Informal document **GRE-77-nn**
(77th GRE, 4-7 April 2017,
agenda item N(x))

**Task Force
on Electro-magnetic Compatibility
(TF EMC)**

Status report of TF to GRE-77
Tuesday, 4. April 2017

(Change of the R10-05 narrow band limit consistent with CISPR 12)

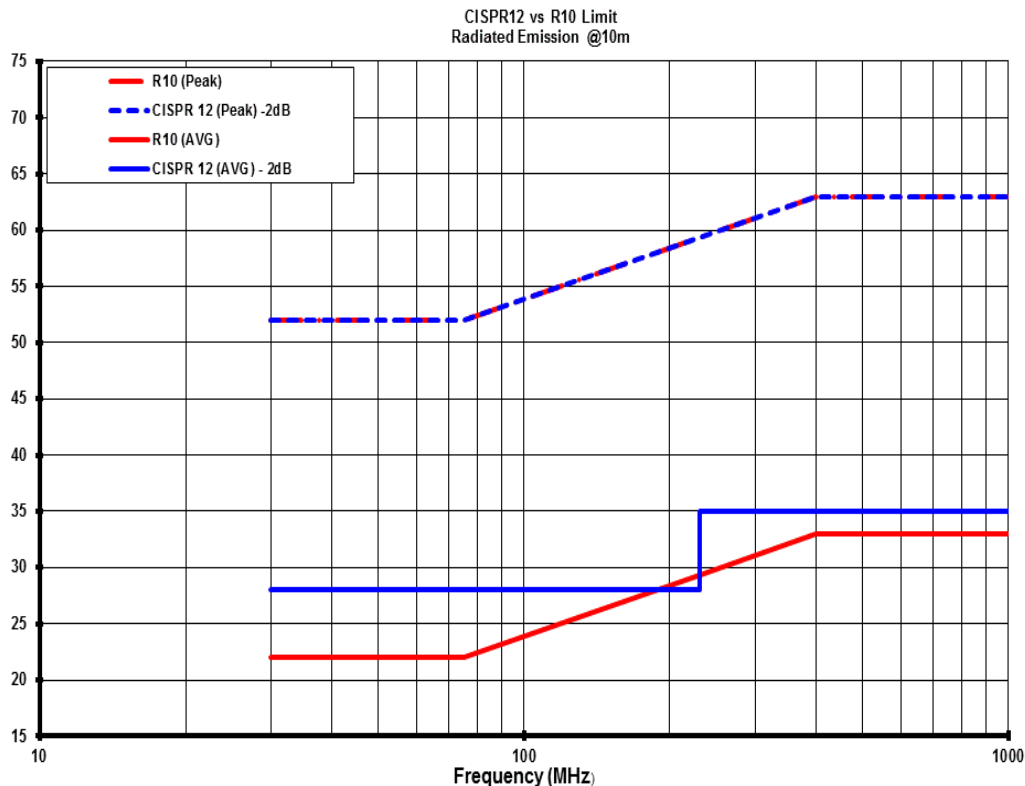
- It has been précised that in order to get a R10-05 vehicle narrowband emission limit consistent with the CISPR 12 vehicle narrowband limit, the **new R10.05 limit should** be the CISPR12-limit minus 2dB to take into consideration this 2dB severisation as defined in CISPR 12 for type approval.

For information:
This figure shows also the consistence between the R10-05 and CISPR12 broadband peak limits.

The proposal for new R10-05 narrowband limit is show in blue, in comparison to the present R10-05 narrowband limit in red.
